## **Disability (Access to Premises – Buildings) Amendment Standards 2020**

### *Disability (Access to Premises – Buildings) Standards 2010*

**Figure D3.2 Doorways and pedestrian entrances for access purposes**

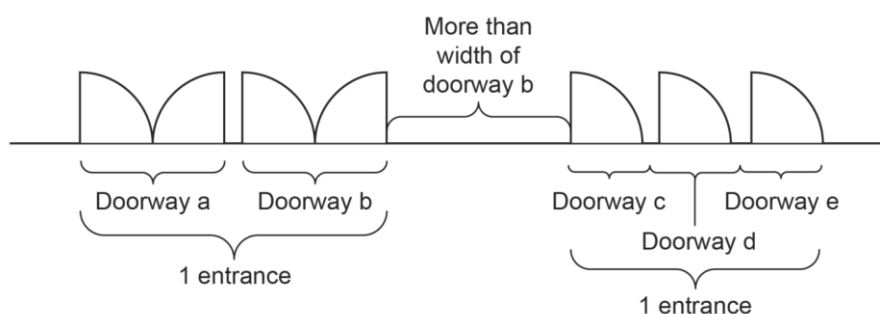
## 21 Clause D3.2 of Part D3 of Schedule 1 (figure D3.2)

Repeal the figure, substitute:

**Figure D5.7 Clear swimming pool surround space for sling lift in the transfer position**

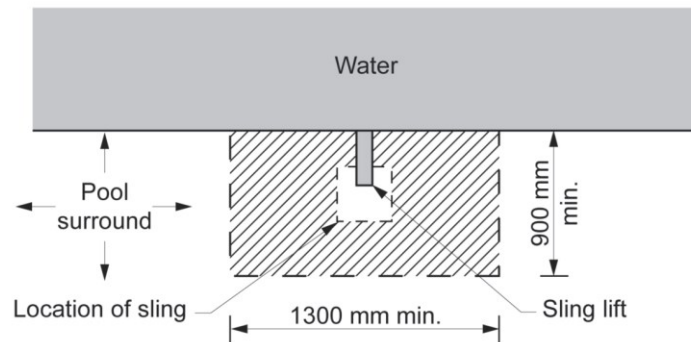
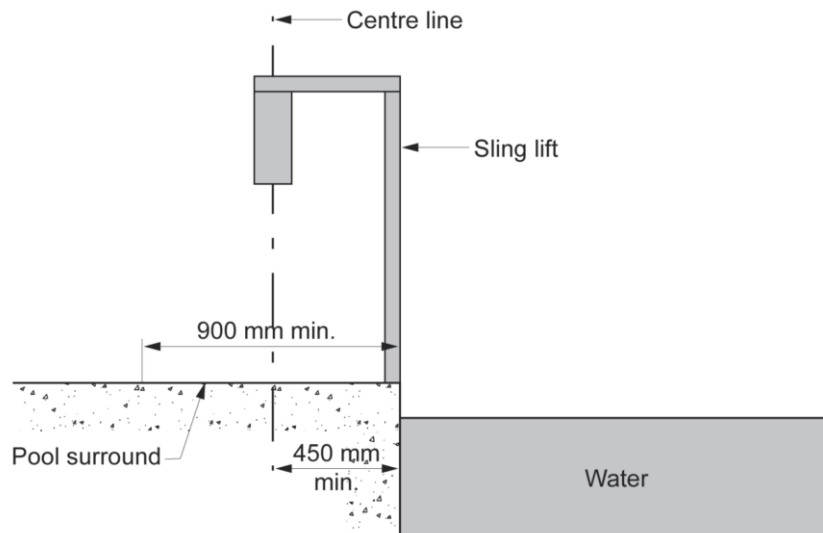
**32 Part D5 of Schedule 1 (figure D5.7)**

Repeal the figure, substitute:

### **Figure F3.2 Required circulation spaces**

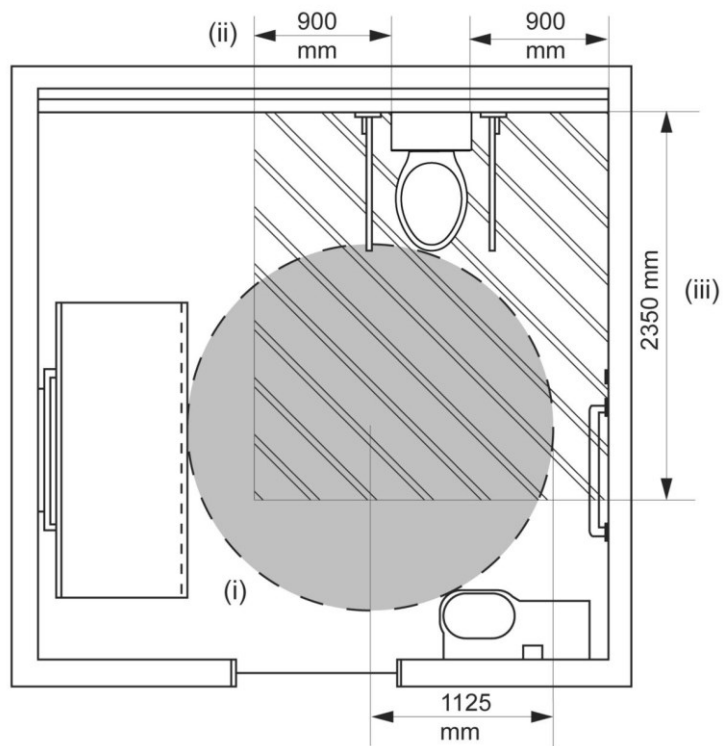
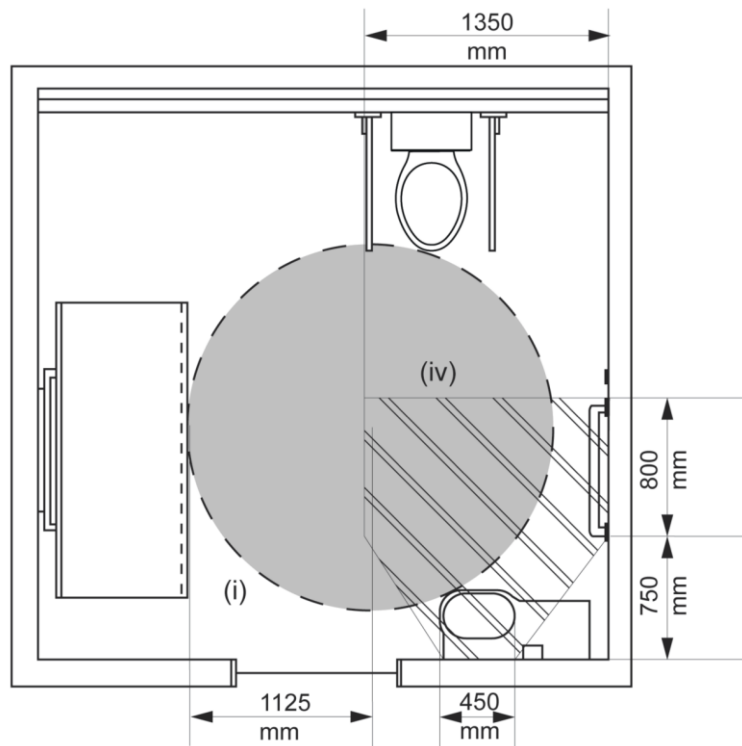
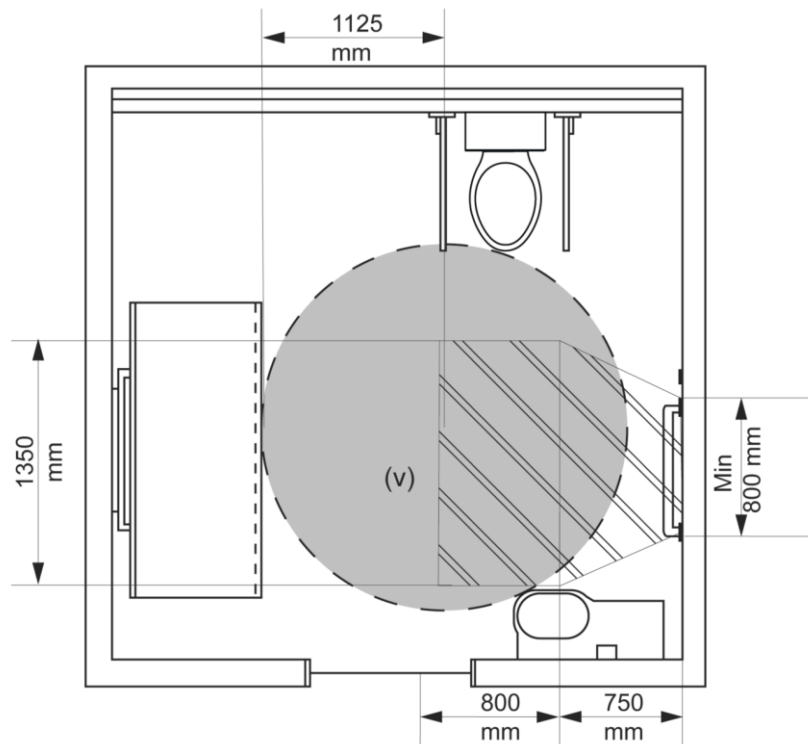
- (j) circulation spaces complying with Figure F3.2.

- (a) The Roman numerals shown in Figures F3.2A, F3.2B, and F3.2C indicate the following *required* circulation spaces:
- (i) turning space—a full circle of 1,125 mm radius;

- (ii) each side of the pan—900 mm (measured from each edge of the pan);
  - (iii) in front of the pan—2,350 mm (measured from the wall behind the pan, and therefore includes the pan itself);

- (iv) for a washbasin—the width of the basin (450 mm) increasing to a width of 1,350 mm measured at a distance of 750 mm out from the wall against which the washbasin is mounted then continuing at that width for a further 800 mm (to a total of 1,550 mm out from the wall);

- (v) for changing rails—the width of the rails increased to a width of 1,350 mm at a distance of 750 mm out from the wall to which the rails are fixed then continuing at that width for a further 800 mm (to a total of 1,550 mm out from the wall).

**Figure F3.10.1 Symbol**

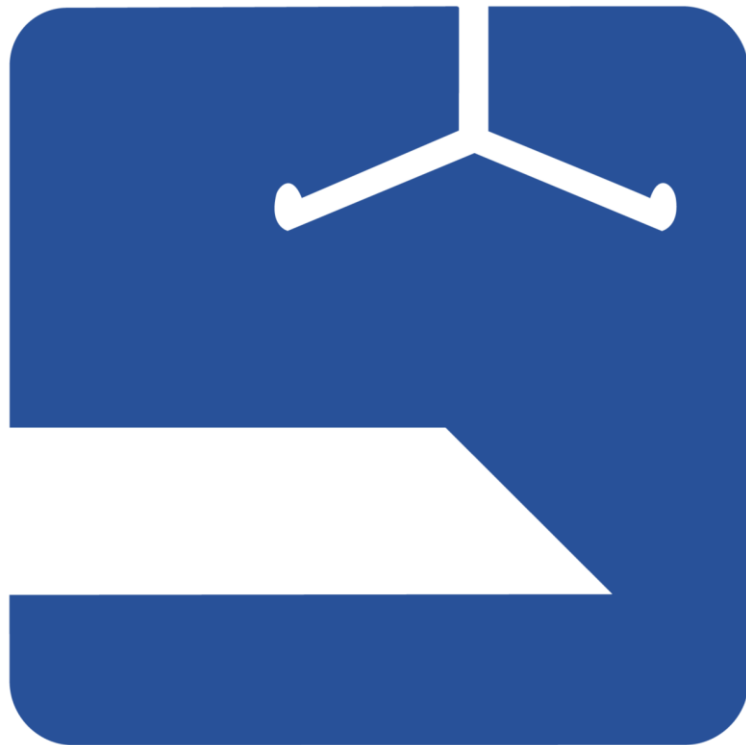
- (1) External signage must incorporate:
  - (a) the symbol shown in Figure F3.10.1; and
  - (b) the words “Accessible Adult Change Facility”.
- (2) The symbol *required* by paragraph F3.10(1)(a) must have a blue (B21, ultramarine) background with the hoist and table elements shown in white.
- (3) Signage must be braille and tactile signage complying with Part D4.
